MIL-P-60633A(MU)
AMENDMENT 2
28 January 1970
SUPERSEDING
AMENDMENT 1
6 October 1969

MILITARY SPECIFICATION

PROJECTILE, 40MM, XM577E1

This amendment forms a part of Military Specification MIL-P-60633A(MU) dated 3 March 1969.

Figure I

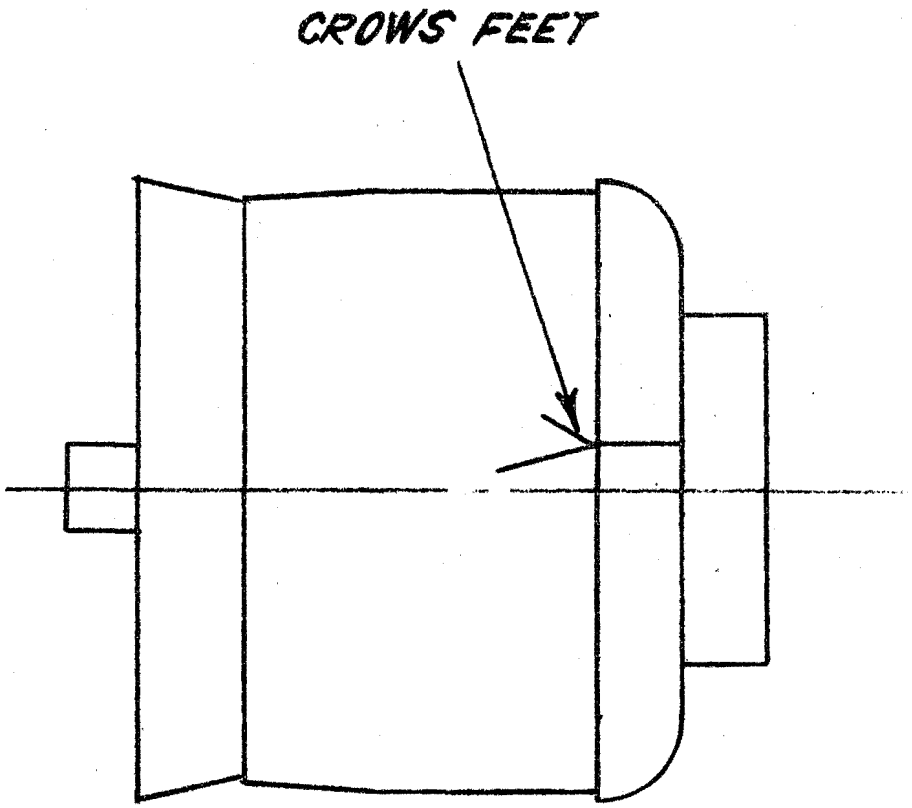
* Paragraph 3.2 Add "crows feet" after the word "porosity"

* Paragraph 4.3.2.7 Add MAJOR 104 and Figure I.
"104. Evidence of crows feet - - - - - - - - - - - - Visual (See Figure I)"
